Goal: Estimate relationship between Shasta Reservoir storage, cold pool storage, and Clear Creek gage (CCR) water temperature and compare to USBR estimates. Note this analysis is referred to as 'NOAA analysis' in this document.

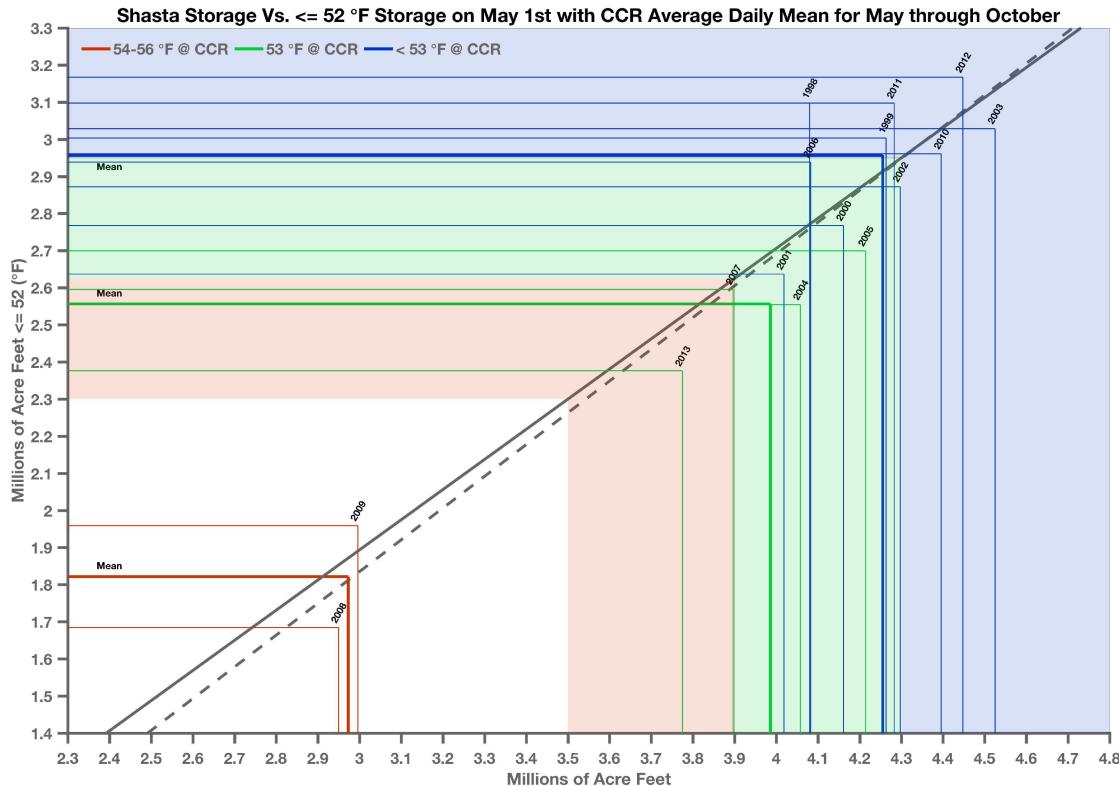
- USBR estimates do not align with NOAA estimates calculated from CDEC and USBR profile data under given assumptions. To resolve, some descriptions of the methods and data used to produce USBR estimate are needed.
- Trend between USBR and NOAA estimates are consistent that greater total/cold pool storage are associated with colder average temperatures at CCR (linear models between cold pool and storage relationship are also similar with USBR estimate slight biased upwards).
- USBR estimates indicates no overlap between CCR temperature criteria and total/cold pool storage while NOAA estimates indicates some overlap (especially under average daily maximum method), more clearly indicating other factors associated with CCR temperatures aside from May 1st total/cold pool storage.
